TO: Public Safety & Transportation Committee
THROUGH: Carl Goldsmith, Director of Public Works
FROM: Dan Watson, P.E., Civil Engineer II
SUBJECT: **2027 N. Main Street Resurfacing Project – Bike Alternative Update**

Village of Lombard
Main Street Resurfacing Improvements

Potential Typical Section

Exhibit A-3a

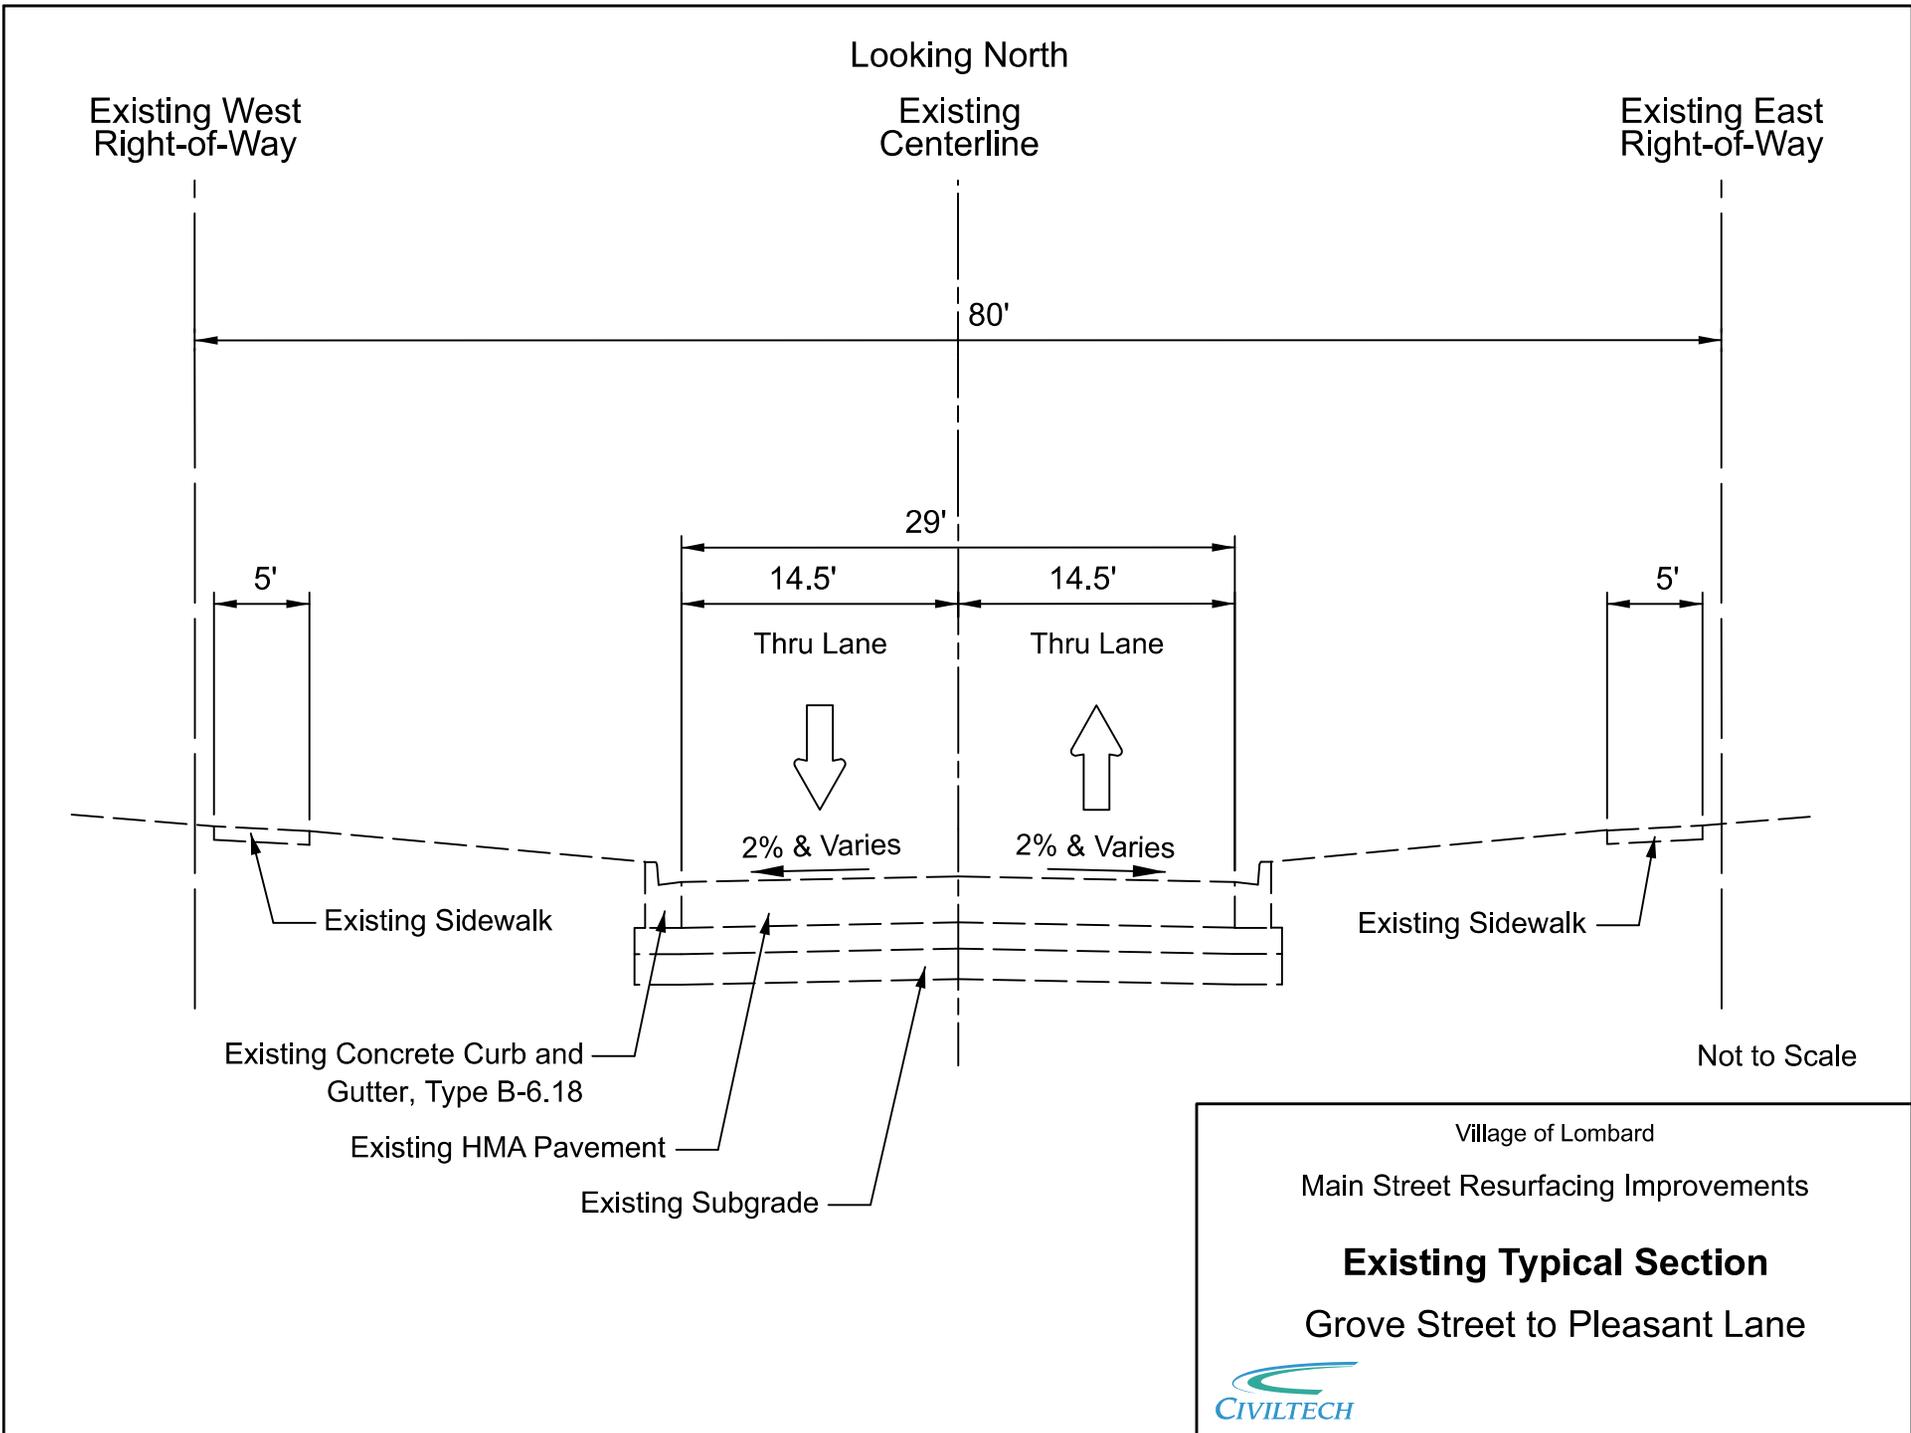
Bicycle and traffic calming improvement alternatives for the 2027 North Main Street resurfacing project were presented at a joint Public Works & Environmental Concerns Committee and Public Safety & Transportation Committee meeting on September 9th, 2025. It was decided at that meeting that the best alternative for bicycles on North Main Street from Grove Street to Pleasant Lane was sharrows. The project consultant (Civiltech Engineering, Inc.) recommended sharrows based on criteria in the current Illinois Department of Transportation (IDOT) Bureau of Local Roads and Streets Manual. See Exhibit A-3a for the existing typical section of North Main Street from Grove Street to Pleasant Lane and the old Exhibit A-4a for the previous proposed typical section with sharrows.

On February 3rd, 2026, staff and the project consultant had a coordination call with the Federal Highway Administration (FHWA) and the Illinois Department of Transportation (IDOT). During this call, IDOT stated that their Bureau of Local Roads and Streets Manual is outdated and would not approve the sharrows for this section of North Main Street. IDOT stated that they would approve a road section that included two 10-foot travel lanes with 4.5-foot bike lanes on North Main Street from Grove Street to Pleasant Lane. See the new Exhibit A-4a for the new proposed typical section on North Main Street from Grove Street to Pleasant Lane.

Staff and the project consultant both agree that the new proposed typical section is the best alternative as we navigate the State and Federal process for this federally funded project. This update was presented to the Public Works & Environmental Concerns Committee on February 10th, 2026.
